HISTORIC AND DESIGN REVIEW COMMISSION

HDRC CASE NO: 2016-488
ADDRESS: 215 CLAUDIA ST
LEGAL DESCRIPTION: NCB 2876 BLK 1 LOT 7
ZONING: RM-4,H
CITY COUNCIL DIST.: 1
DISTRICT: King William Historic District
APPLICANT: Ricardo McCullough
OWNER: Vidal Gonzalez
REQUEST:

The applicant is requesting a Certificate of Appropriateness for approval to:

1. Construct a single story addition to the rear of the primary historic structure.
2. Construct a two story apartment at the rear of the lot.

GARAGE 1st FLOOR PLAN

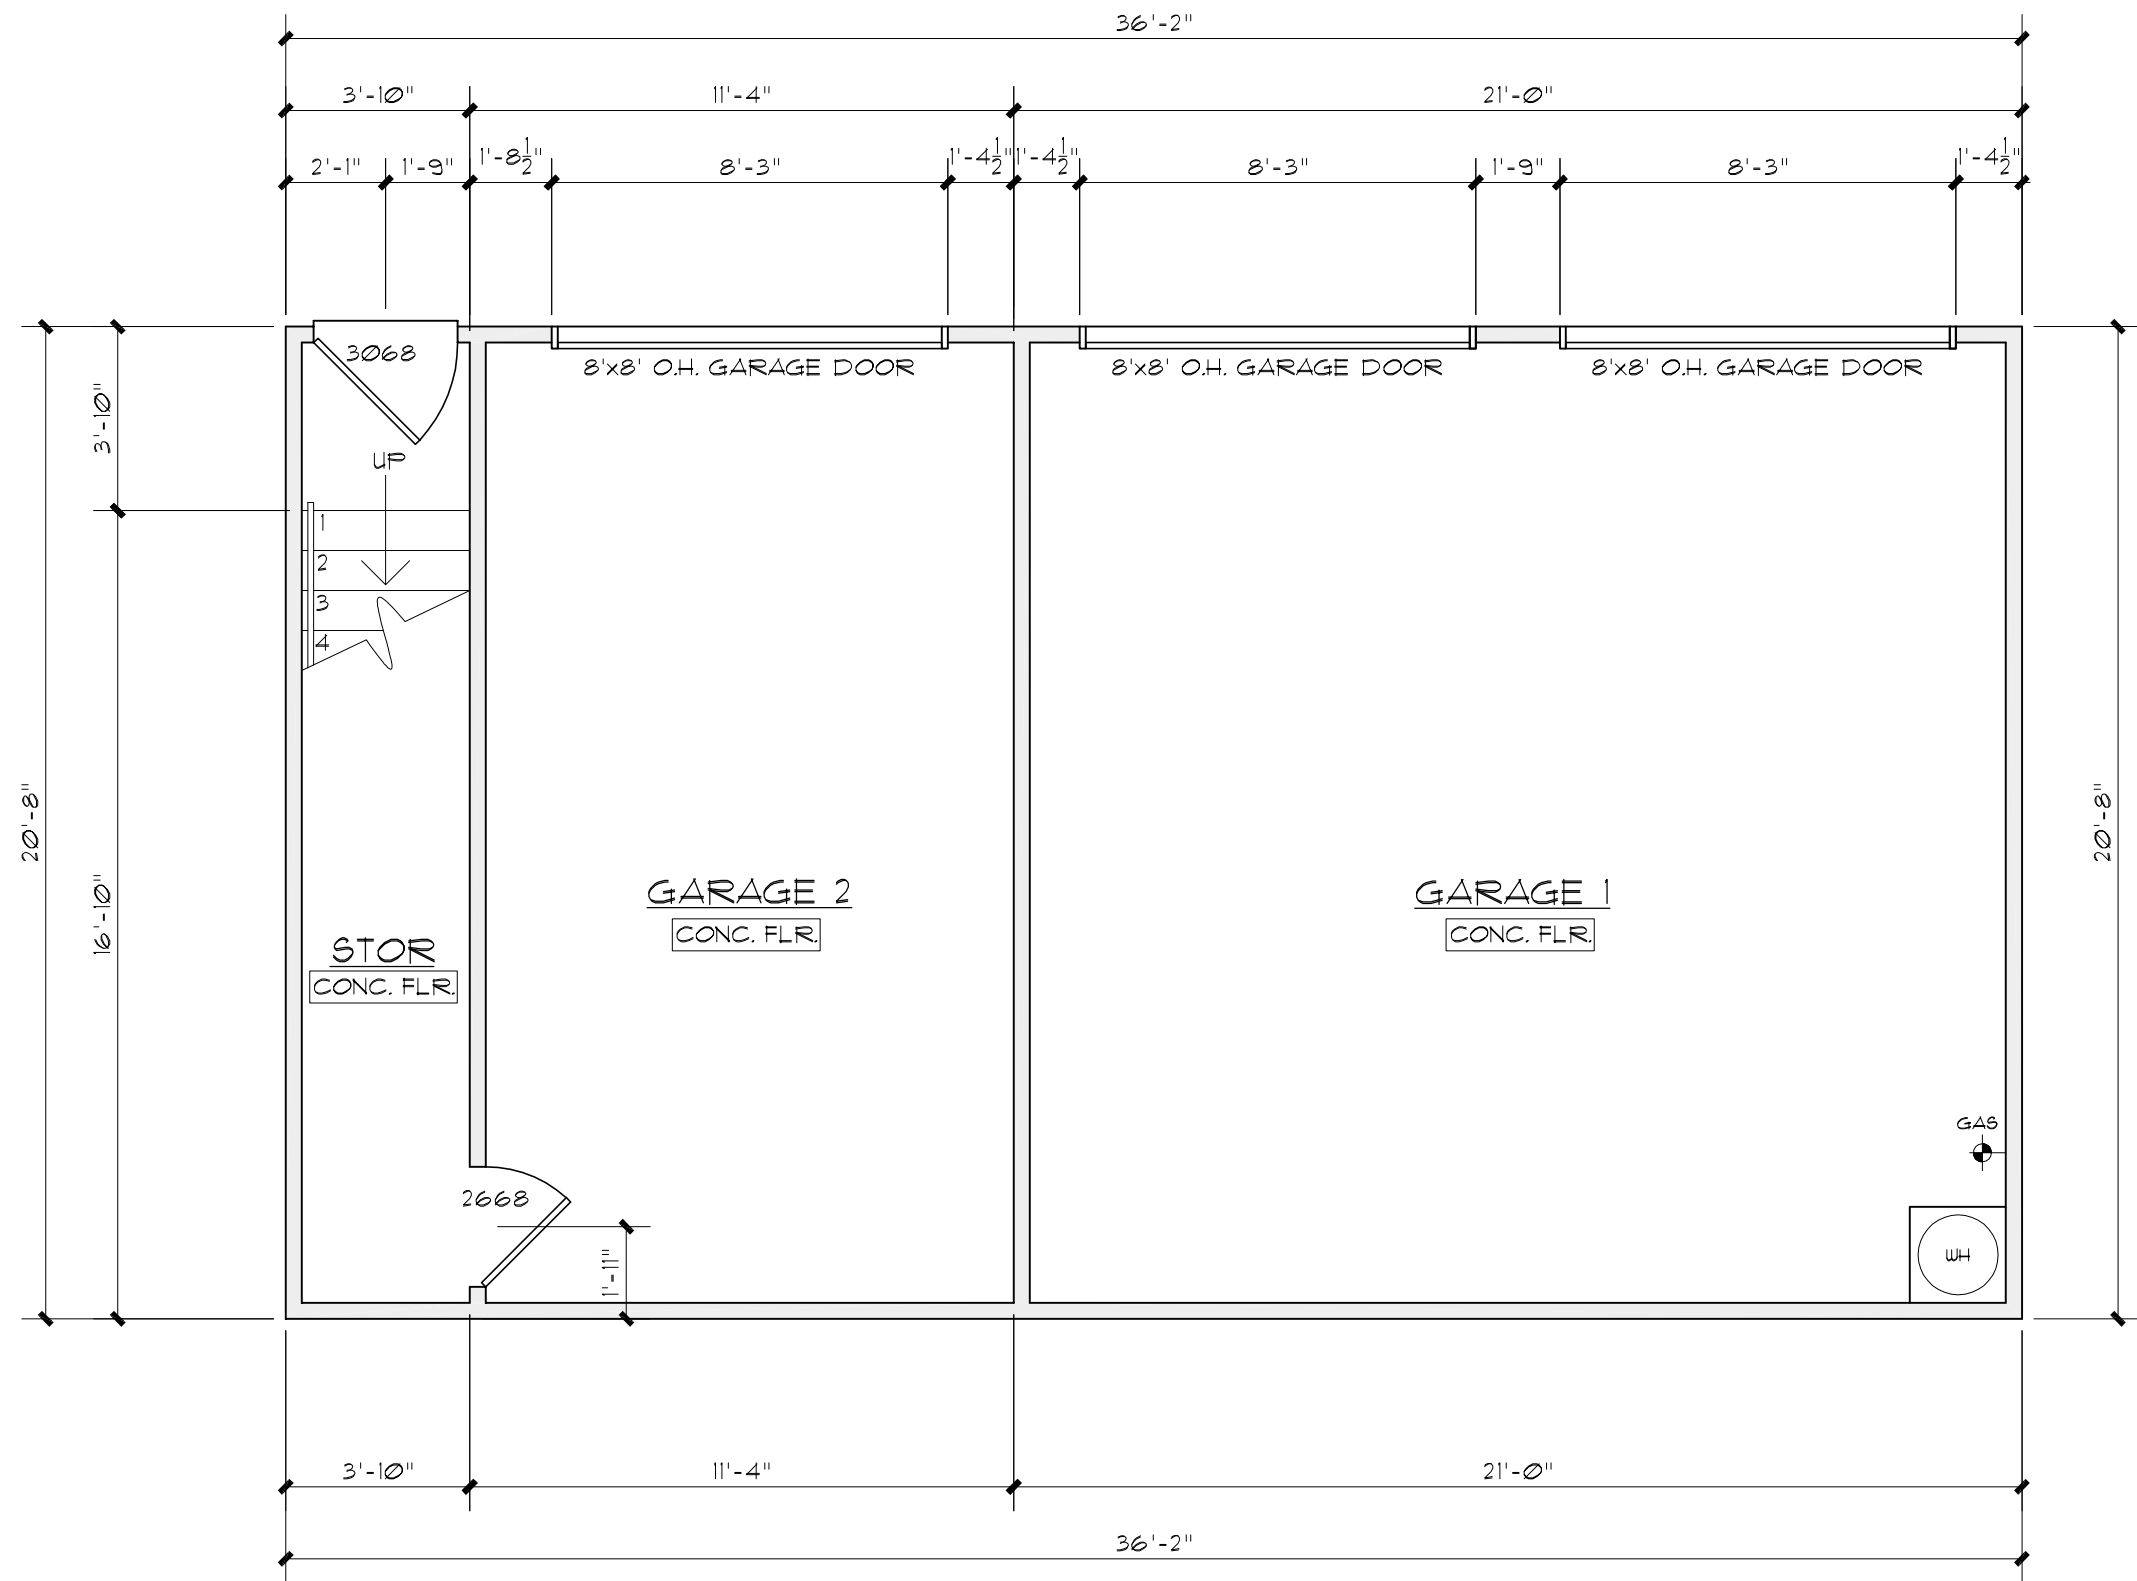
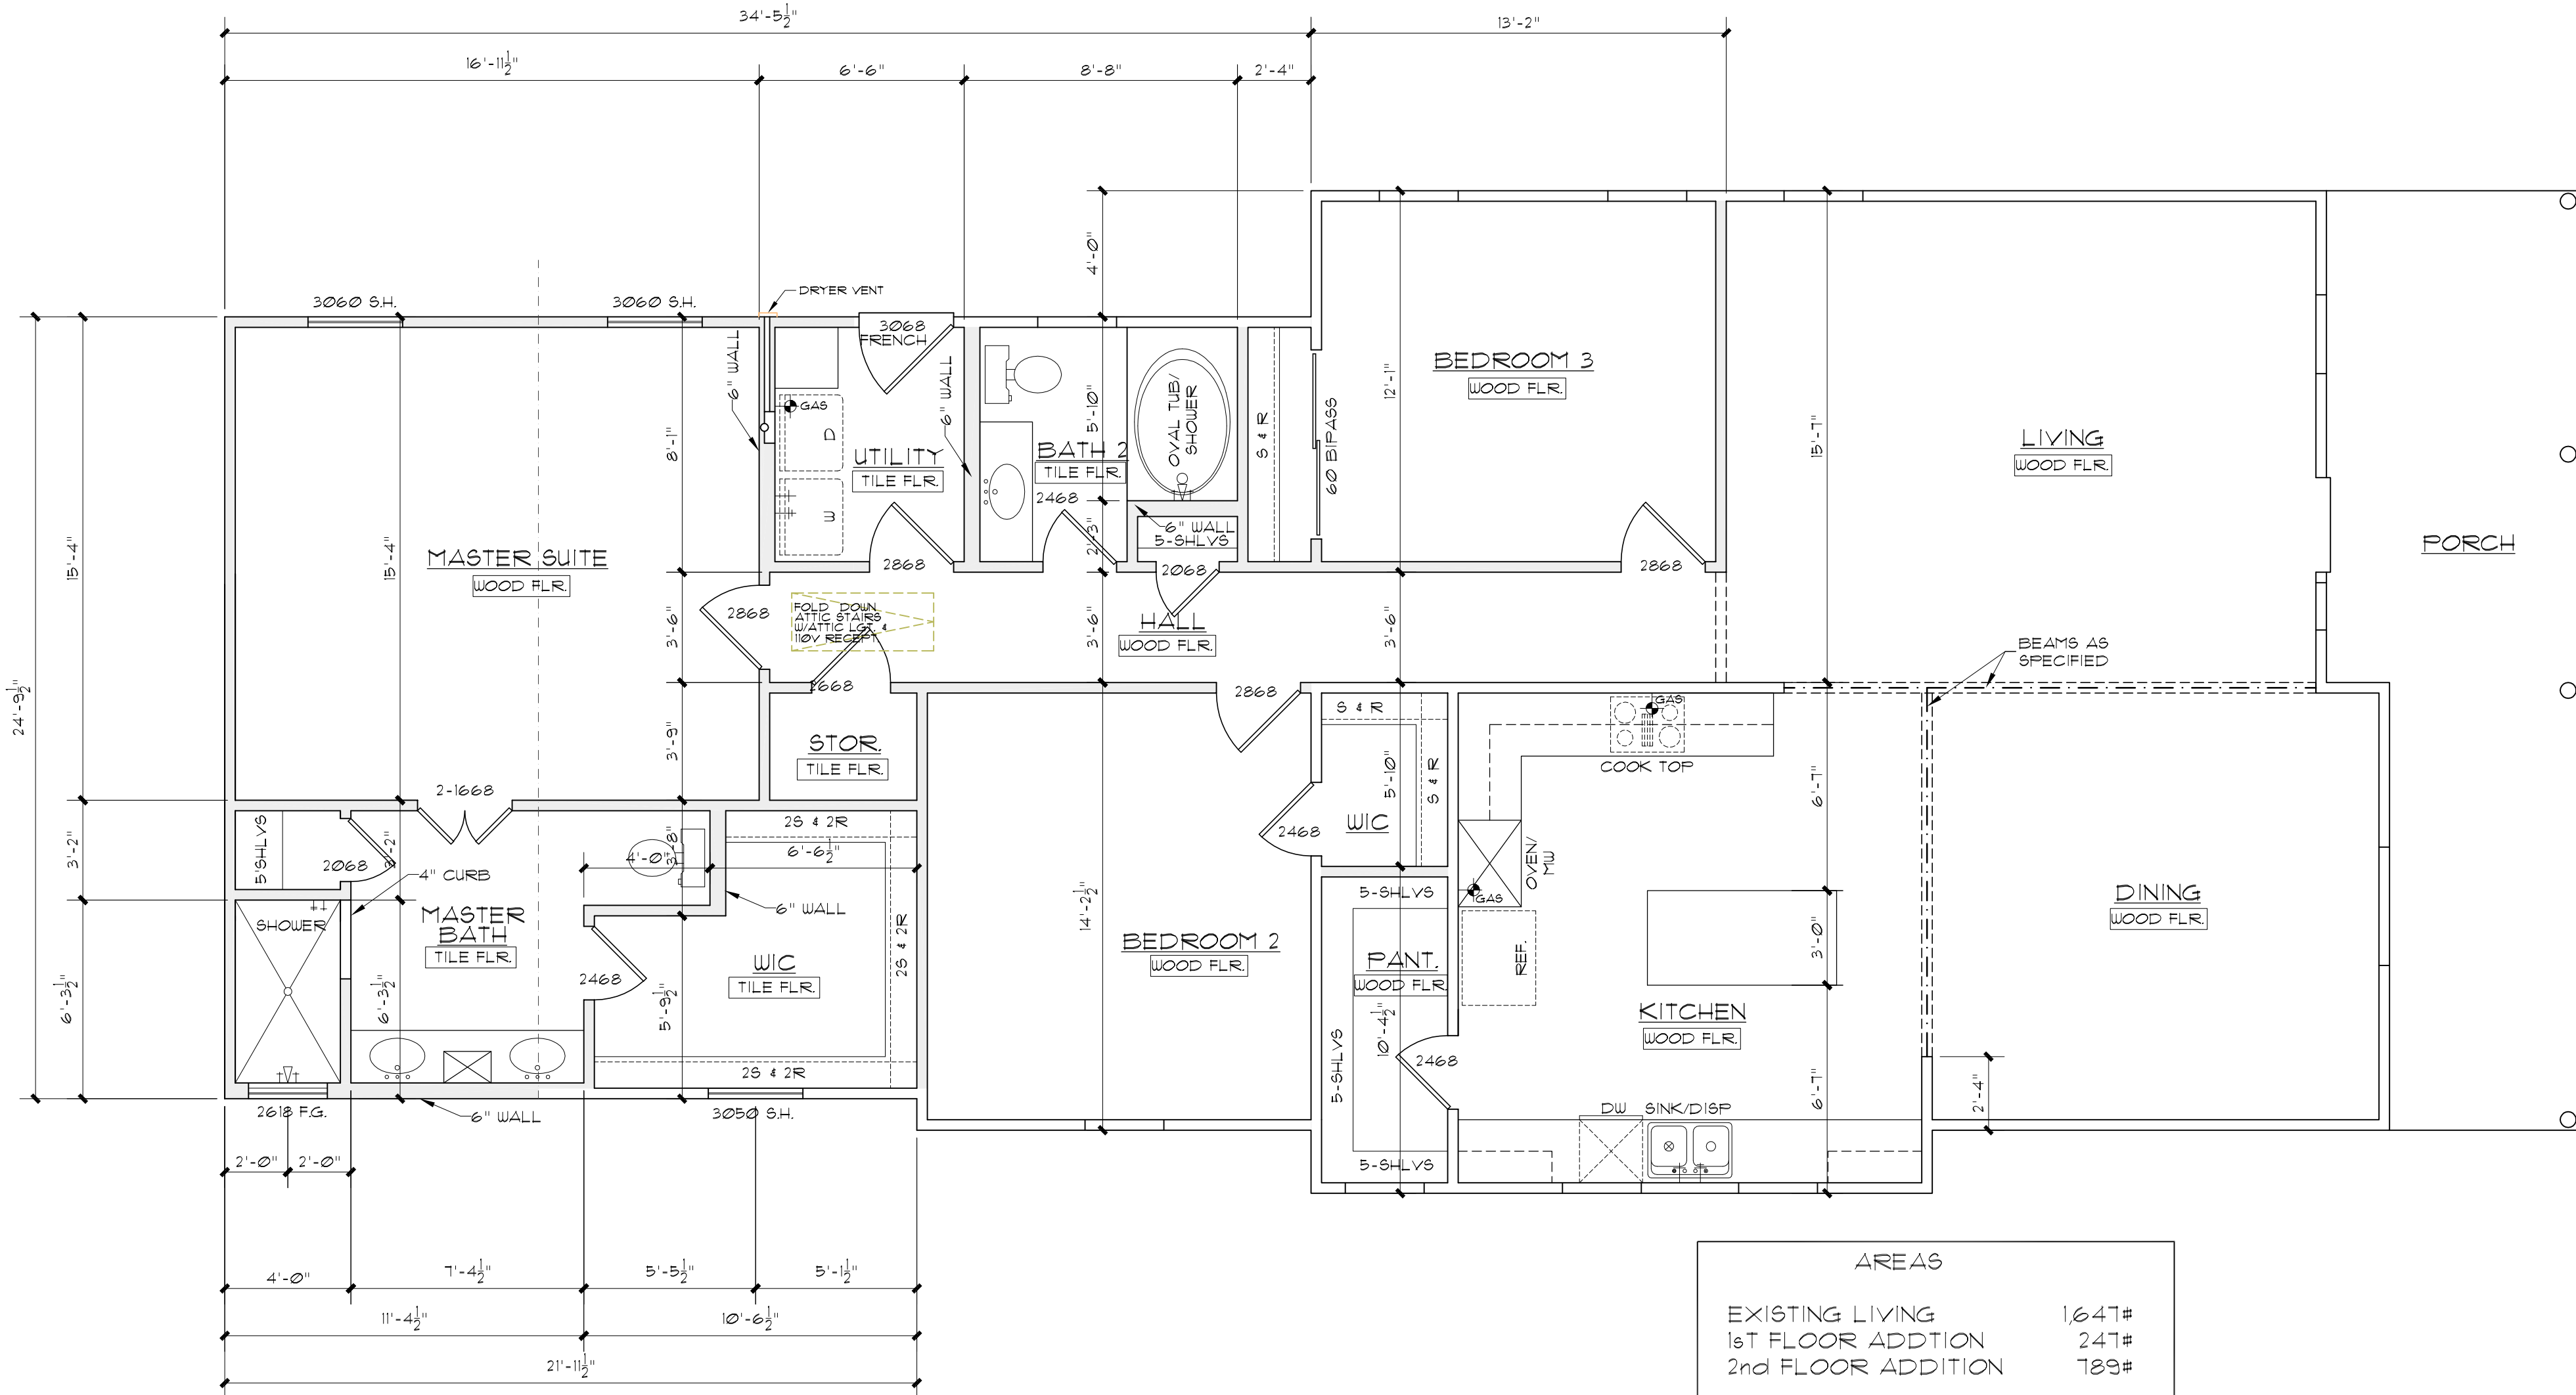
Staff recommends approval of items #1 and #2 based on findings a through g with the stipulation that the applicant include additional window fenestration on both the rear façade of the proposed rear addition and the ground floor of the proposed garage.
